**Historic District Review Board Regular Meeting Agenda  
August 13, 2025**

**To:** Historic District Review Board **Date:** 08/06/2025  
**From:** Nicolas Navia, Community Development Planner I  
**Item Name:** 404 Scott Street, PIN R120 004 000 0809 0000, addition  
Applicant: Thomas Rhodes, Architect  
**Meeting Date:** August 13, 2025  
**Department:** Community Development Department

# Fulton - 404 Scott Street

# FULTON PORCH

① North  
 1/4" = 1'-0"

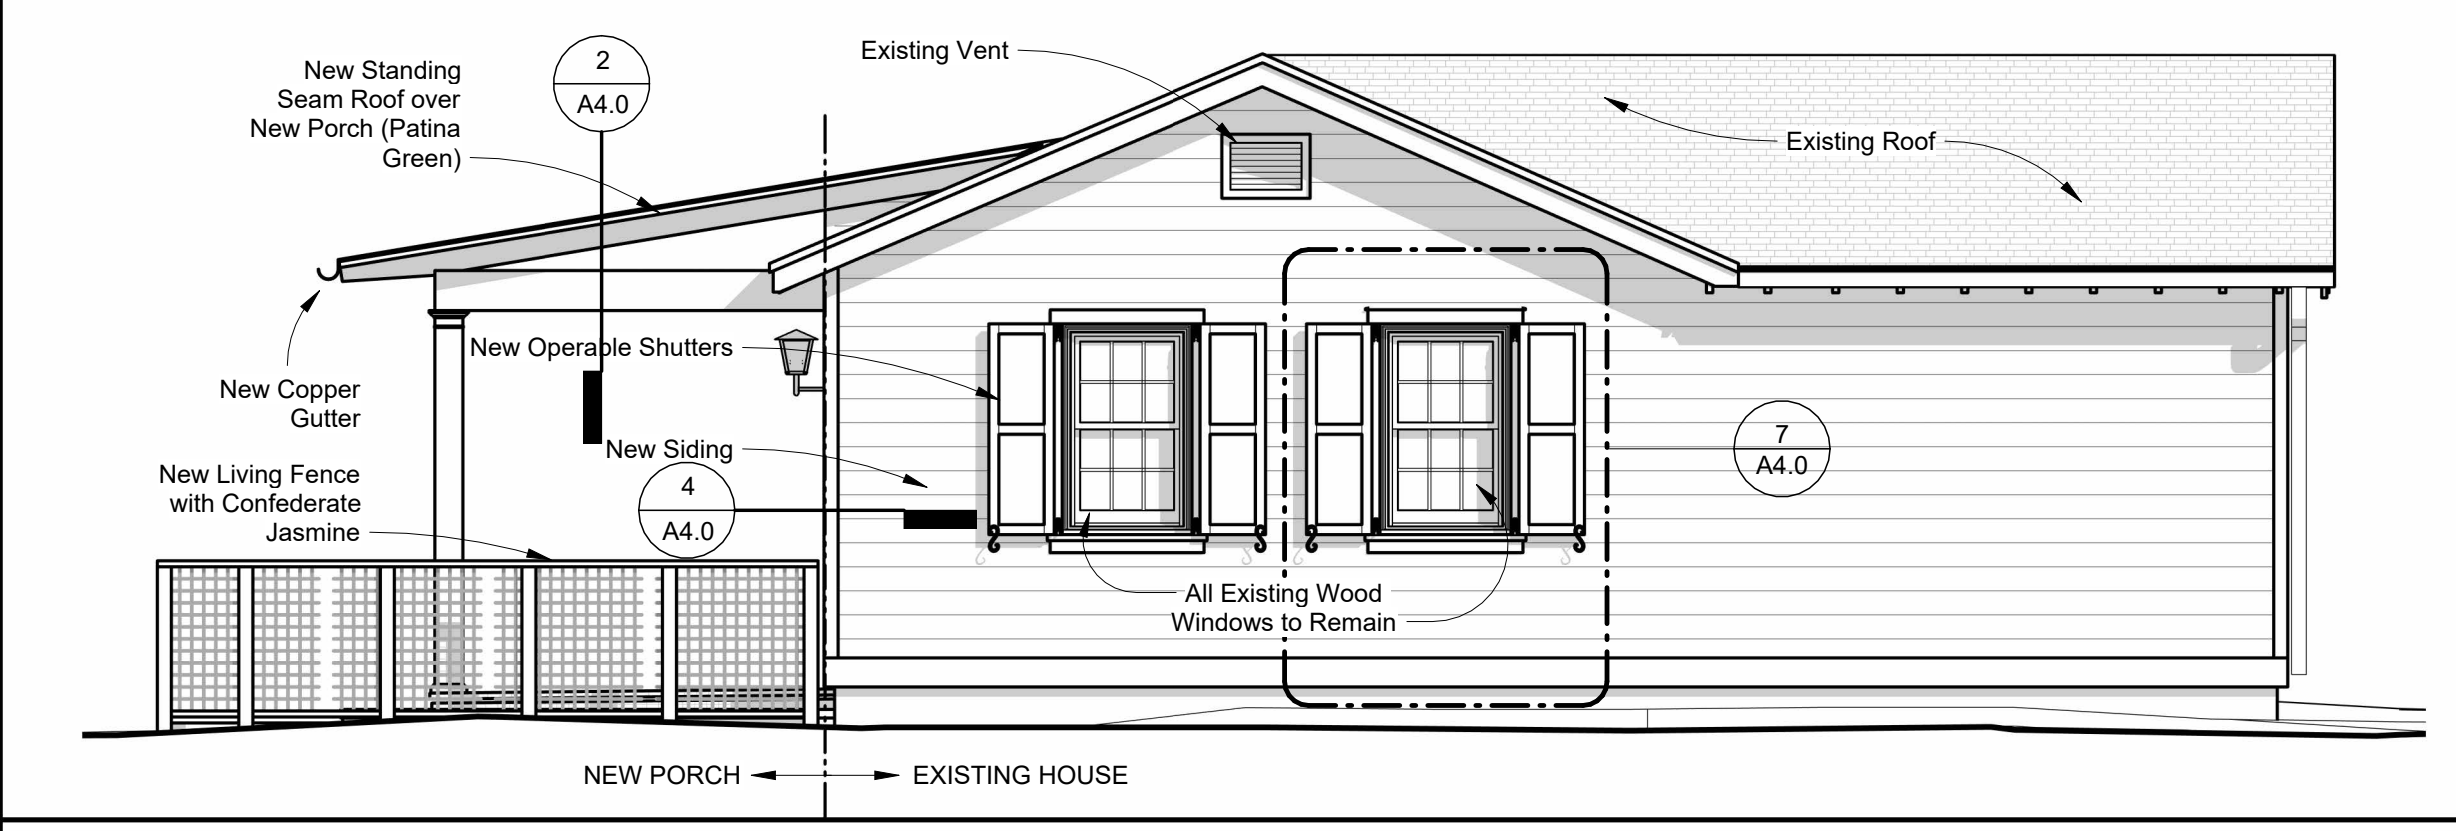
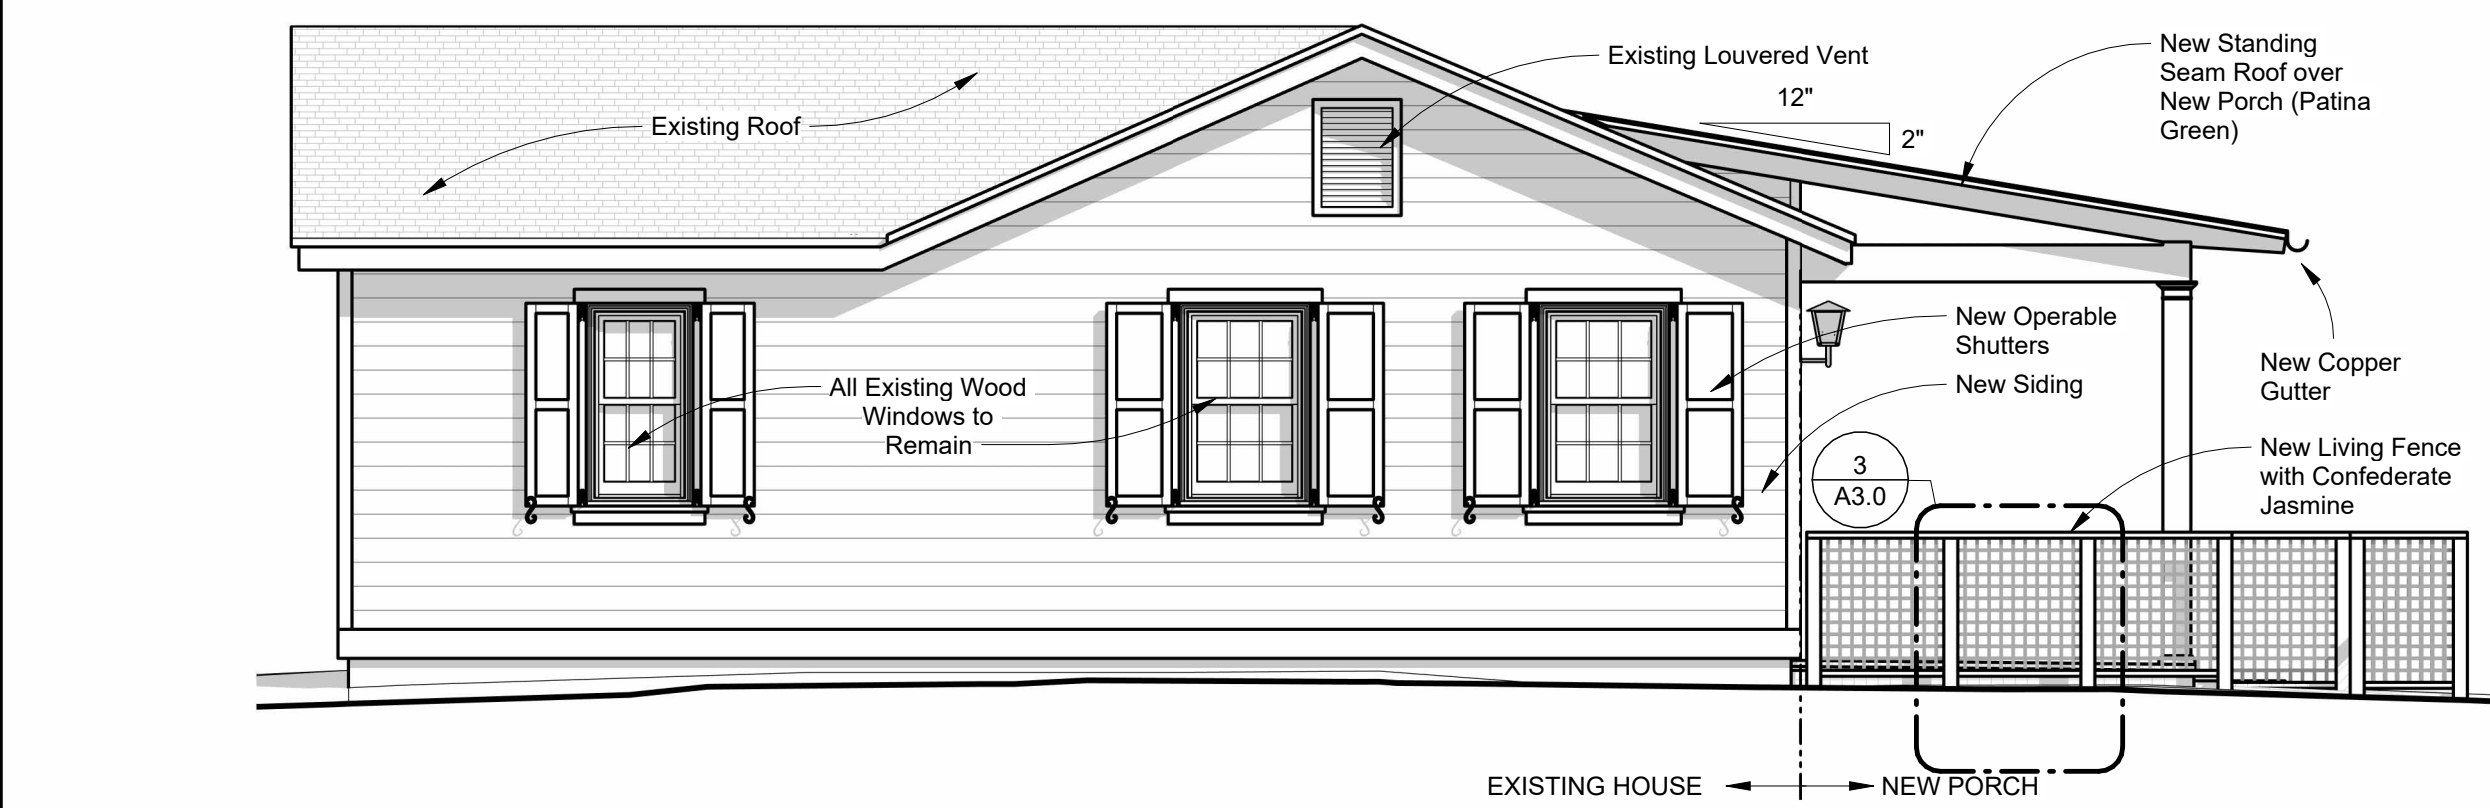
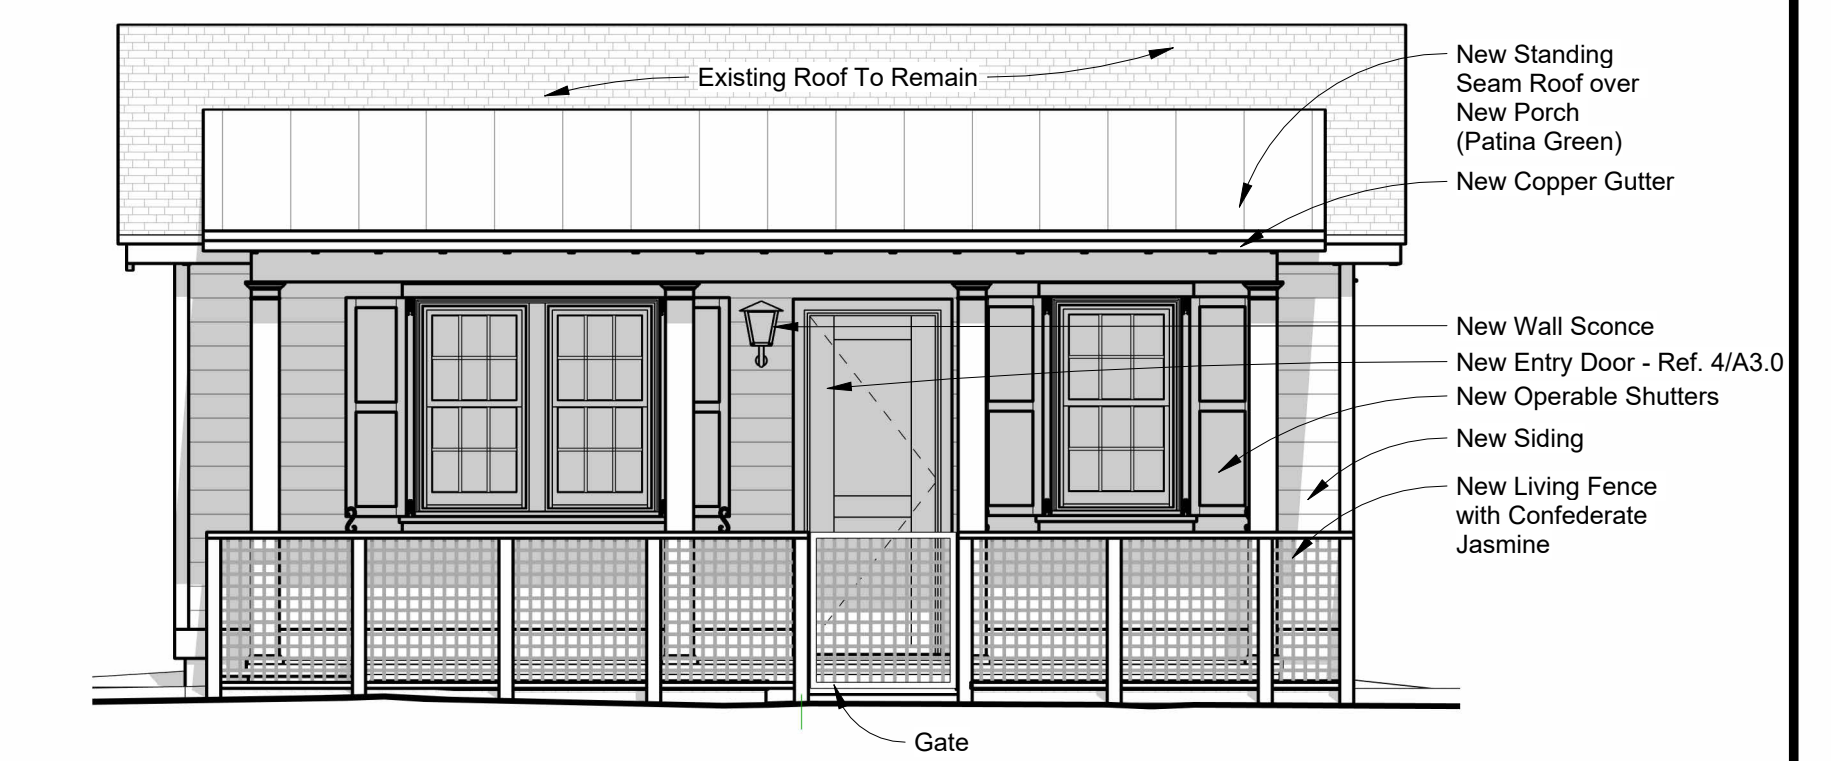
1. **Staff recommends selecting a different color for the standing seam metal roof. Staff has concerns that the "Patina Green" color selected by the applicant will appear too different in color next to the existing dark gray asphalt shingle roof, even though it**
-

is a low-slope roof. Staff recommends selecting a gray color to match the existing roof. Staff is supportive of the siding/trim/window color, shutter color, and porch ceiling color.

③ EAVE DETAIL  
 1 1/2" = 1'-0"

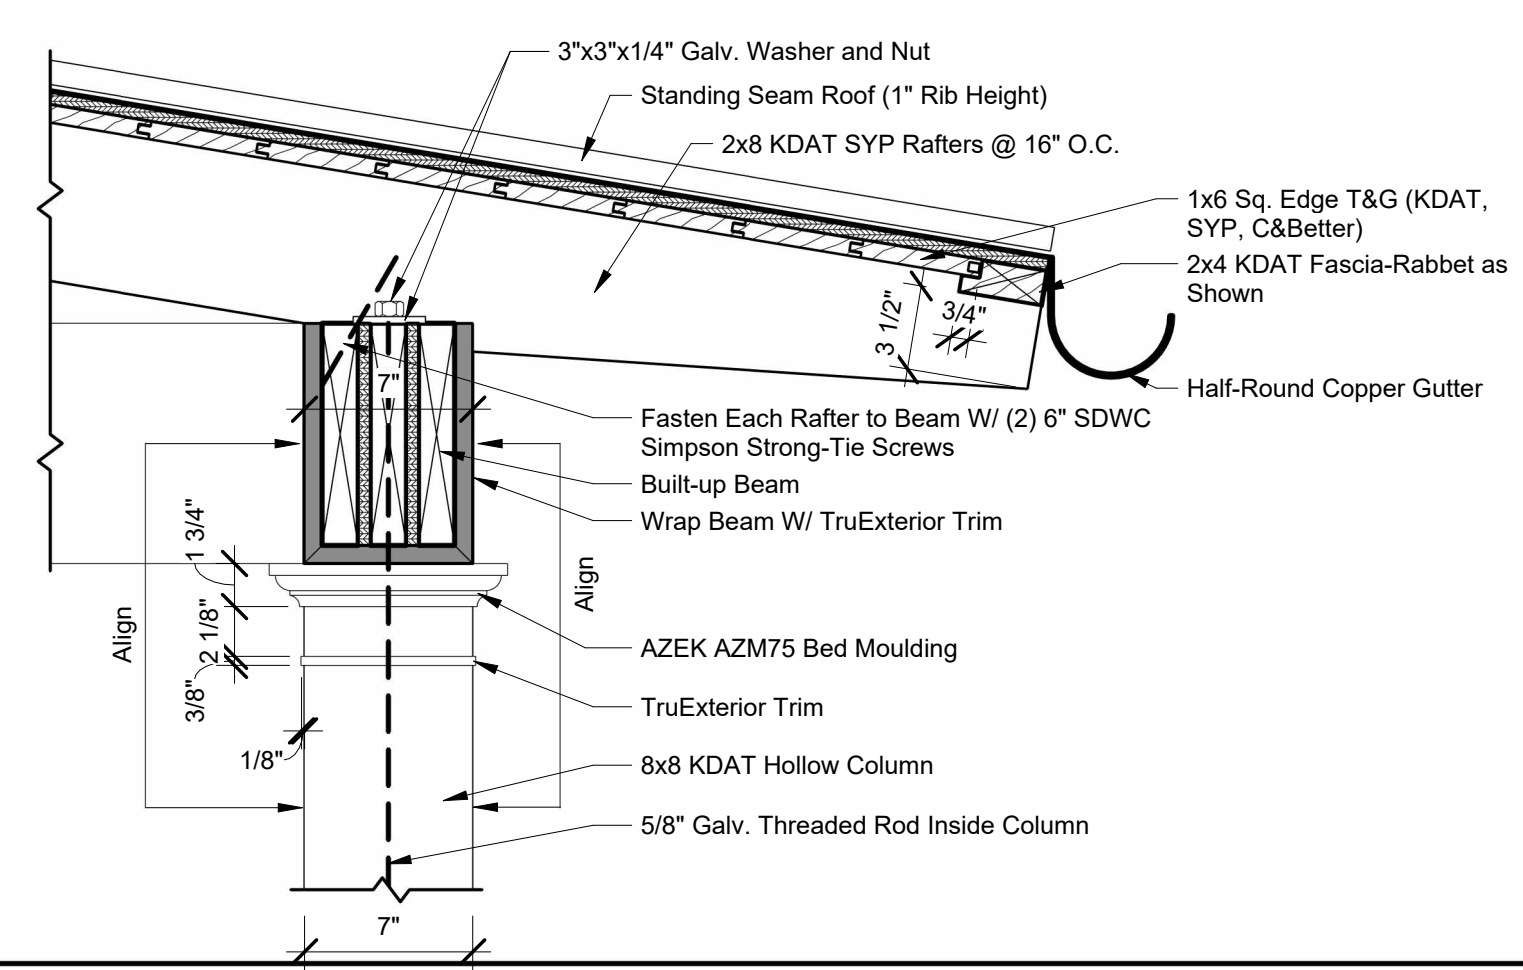
- The roof appears thin – provide accurate detail
  - Applicant to provide a section through the porch, as well as a typical eave and rake detail.
  - Applicant to note that the living fence cannot exceed a height of 4’-0”.
